**32-34 Hancock Street Condominiums  
Beacon Hill Architectural Commission (BHAC)  
PART III APPENDIX A - WRITTEN DESCRIPTION OF PROPOSED WORK**

**24 May 2017**

**Re: Continuation to the 18 May 2017 Beacon Hill Architectural Commission (BHAC) Hearing**

## PART III - Appendix B: Supplemental Information for Boston Landmarks Commission / Beacon Hill Architectural Commission Application for Certification of Appropriateness

Proposed Site Plan

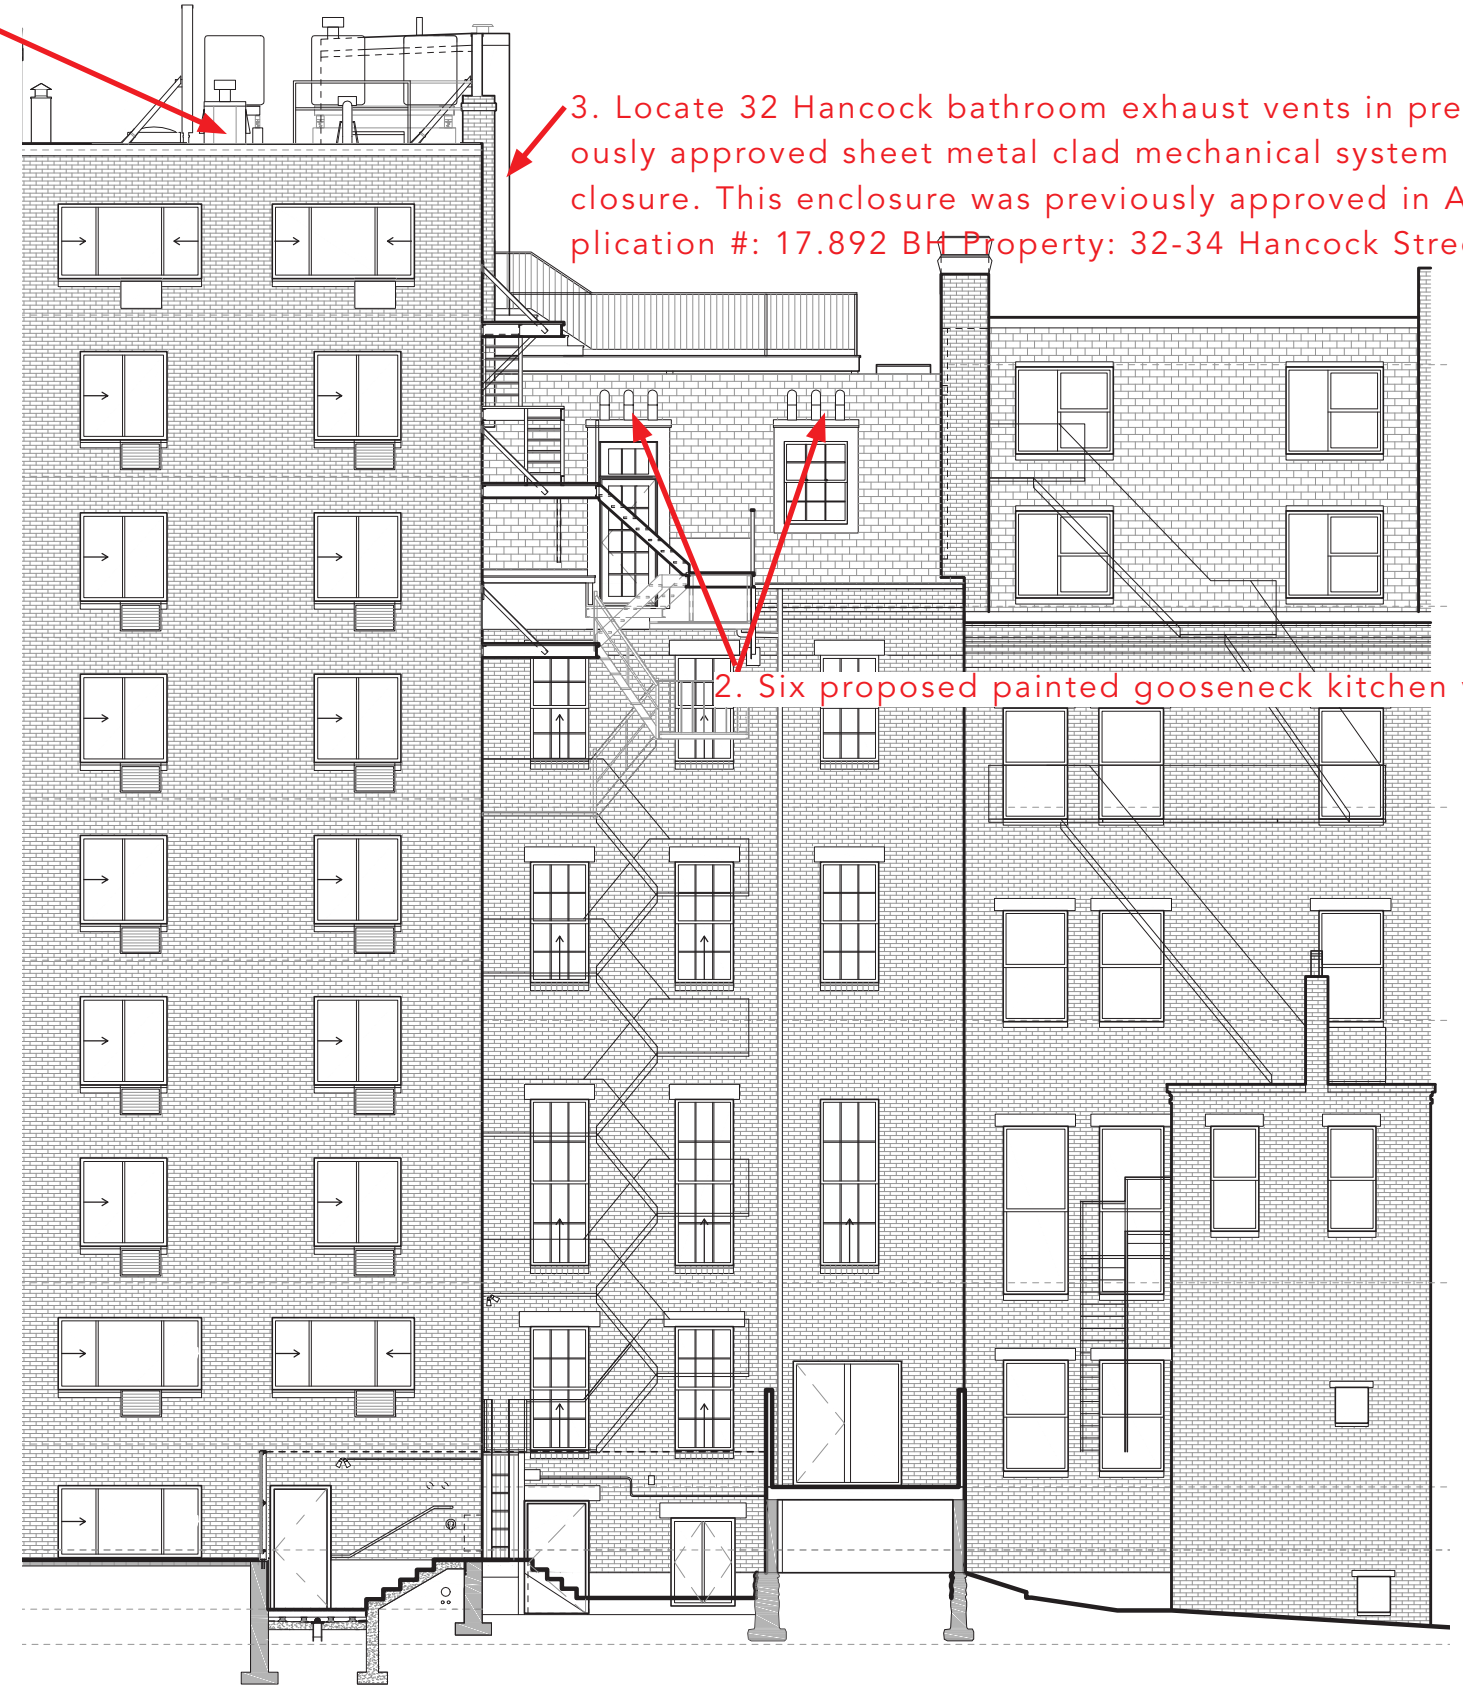
1. Proposed painted sheet metal clad rooftop Mechanical venting enclosure for 34 Hancock Kitchen and Bathroom vents.

3. Locate 32 Hancock bathroom exhaust vents in previously approved sheet metal clad mechanical system enclosure. This enclosure was previously approved in Application #: 17.892 BH Property: 32-34 Hancock Street.

2. Six proposed painted gooseneck kitchen vents.

**B: ROOF PROPOSED PLAN**

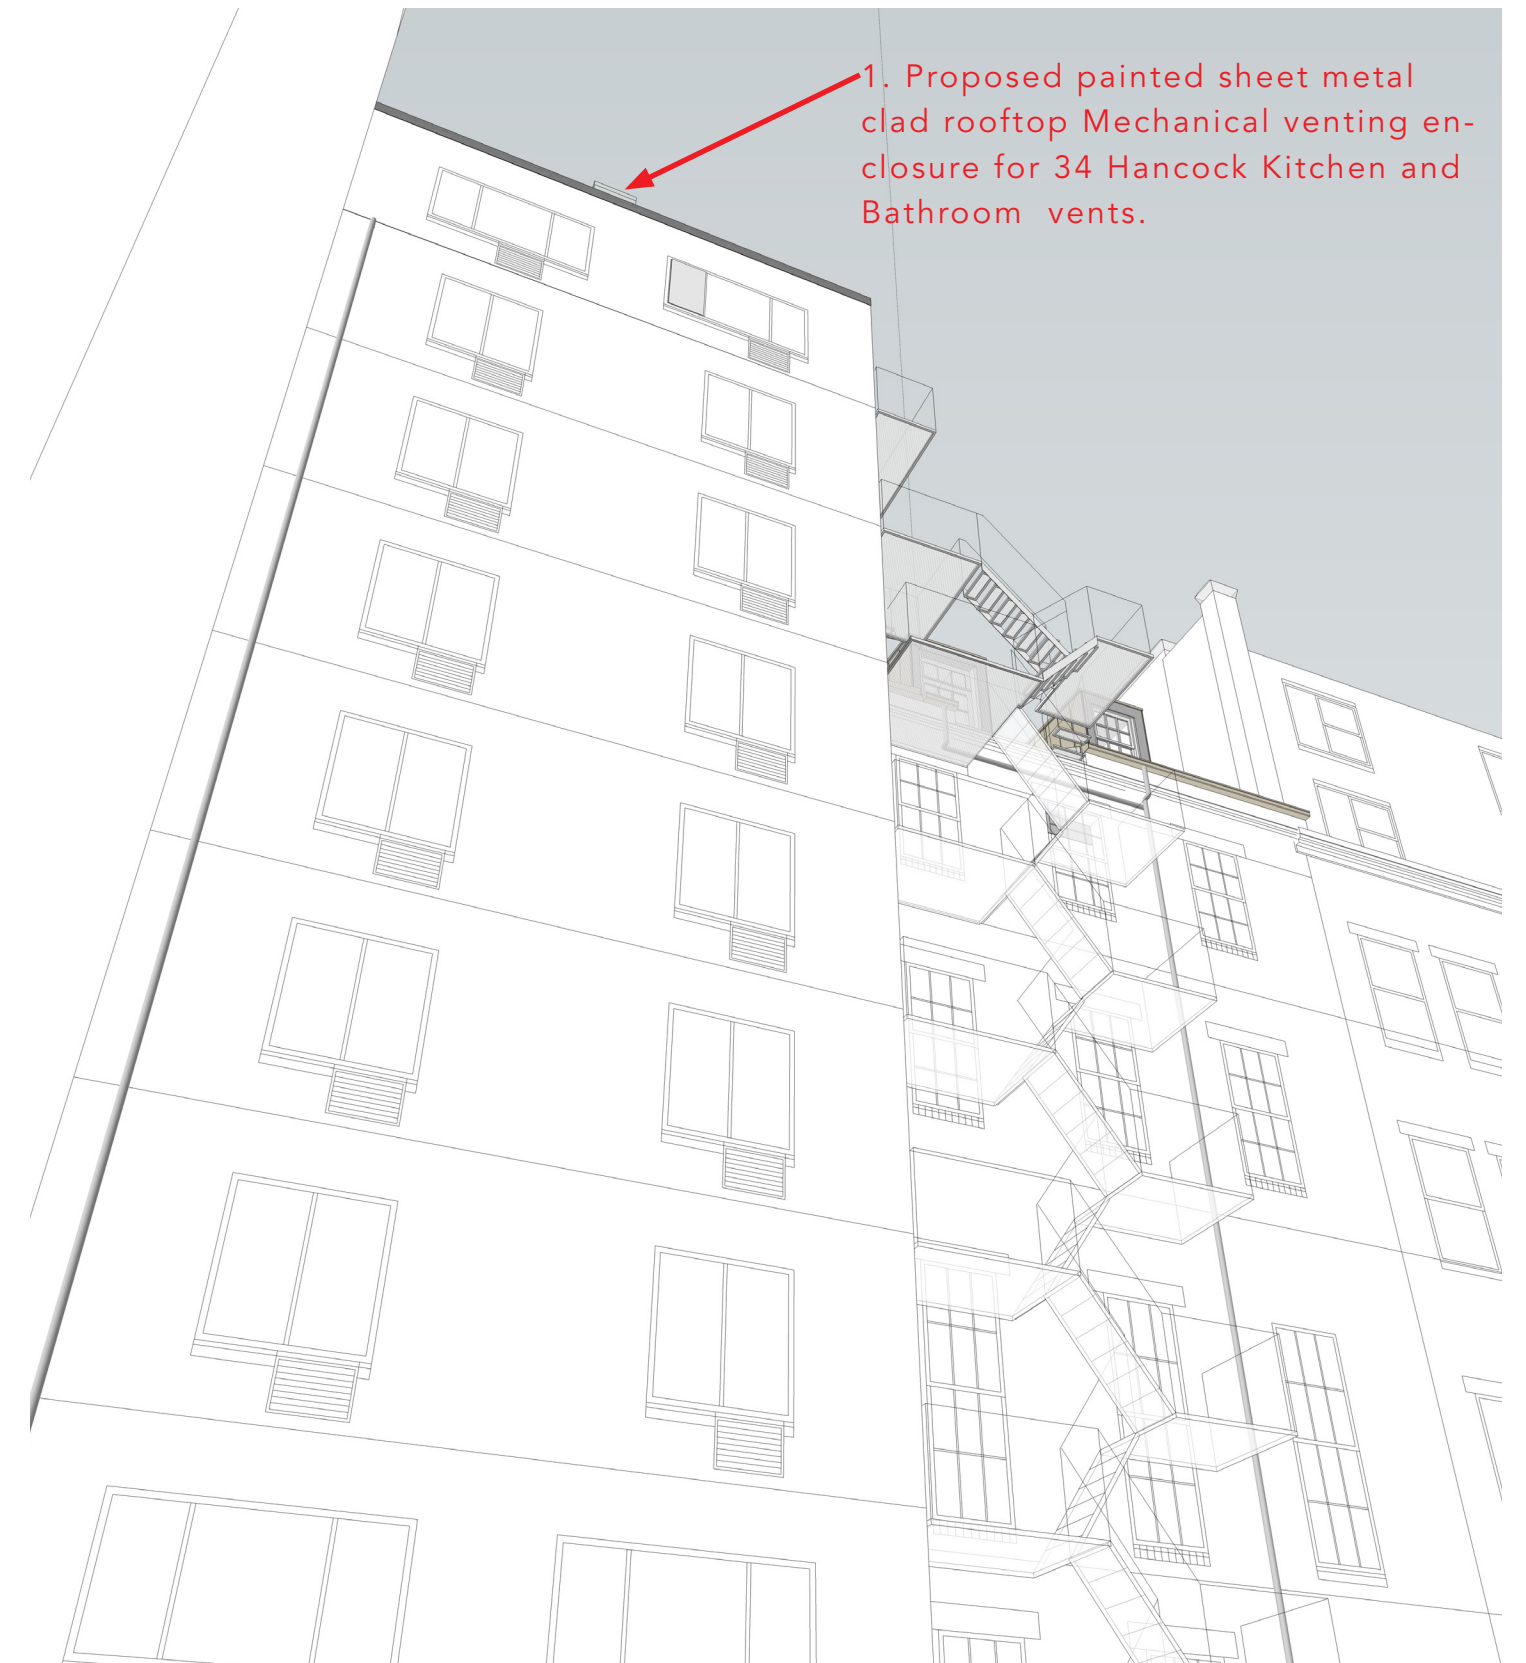
- At the 18 May 2017 BHAC Hearing, the Commission concluded that the proposed exterior projected vent wall hoods on the Ridgeway Lane side of the 32 and 34 Hancock Building elevations were not acceptable. Please find attached proposal that includes the following revisions:  
34 Hancock Street: Reroute the bathroom and kitchen exhaust vents to an internal building chase along the east elevation rear wall. Vent bathroom and kitchen exhaust through the roof.  
32 Hancock Street: Reroute the bathroom and kitchen exhaust vents to an internal building chase along the north party wall and then offset the kitchen exhaust above the Ridgeway Lane elevation dormers and the bathroom exhaust through a previously approved chase to the roof of 34 Hancock Street.
